**Item 3.****Development Application: 9 Billyard Avenue, Elizabeth Bay**

File No.: D/2018/57

Figure 9: Proposed Ground Floor Plan

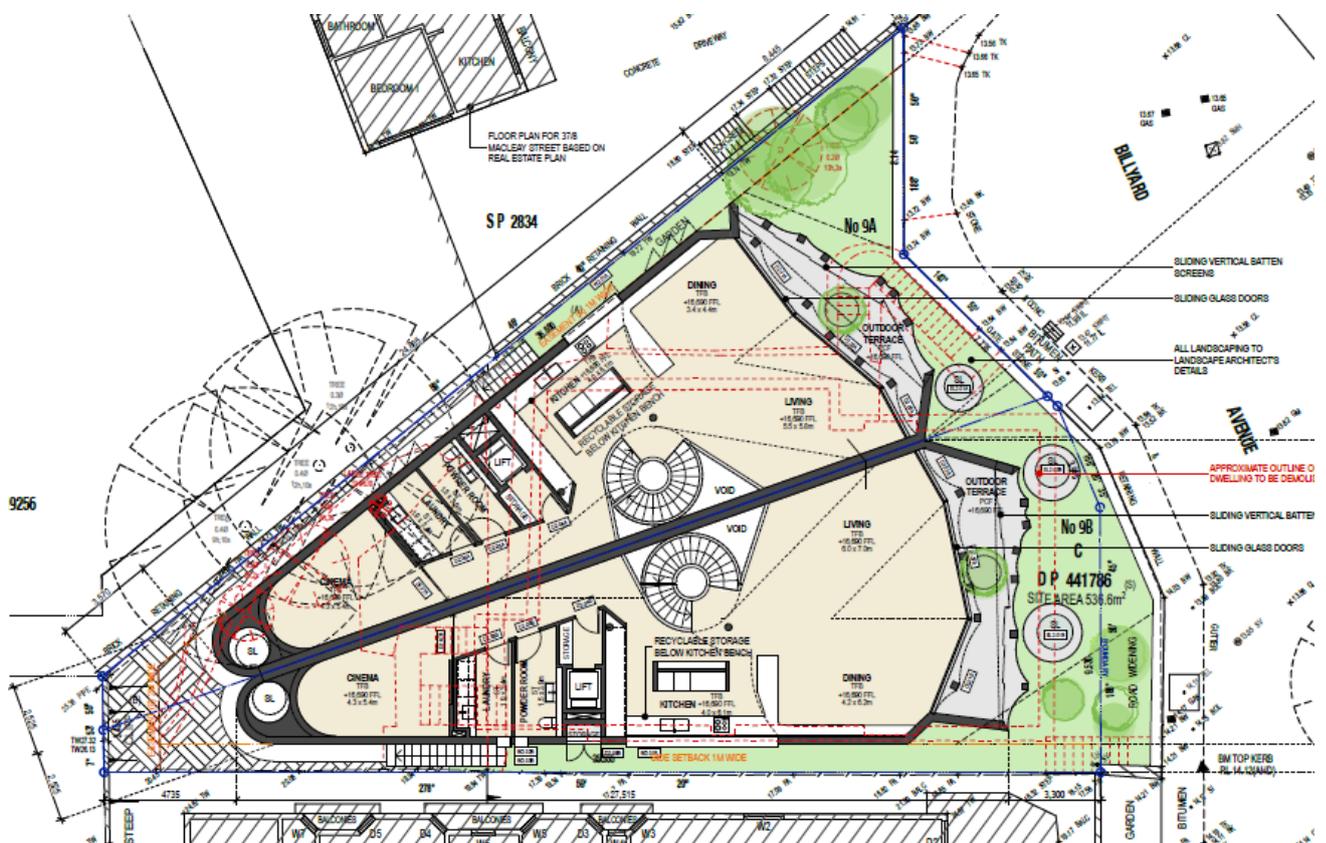
63. The proposed 'cinema room' with no windows should be amended in the design to include windows for natural light and ventilation, noting the risk that this could be converted to a bedroom at a later date. Similarly the ventilation strategy for the proposed gym was questioned.

**Response:** Advice regarding BCA is that both spaces are capable of complying with the NCC with performance solutions provided by a suitably qualified professional. It is also noted that both spaces will receive some natural light from an overhead skylight.

**Figure 17:** Solar access diagram to east (front) elevation of 11 Billyard Avenue, with the 'yellow' indicating increase to solar access.

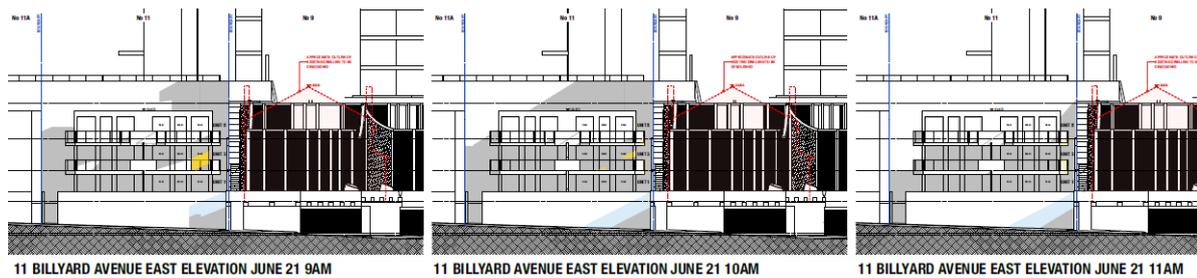
46. The proposal is considered to improve solar access to the majority of the units at the neighbouring property to the south at 11 Billyard Avenue.
47. The applicant has undertaken a specific analysis of this building and it is noted that the proposal will increase solar to the front balcony; however, there will be some additional shadow on the north facing (side) living room between 9am and 12 noon. However, it has been demonstrated that 1h 45m of direct solar access is retained to the living room glazed doors of Unit 5 (between 9am and 11:45am) and solar access is improved to Unit 3.
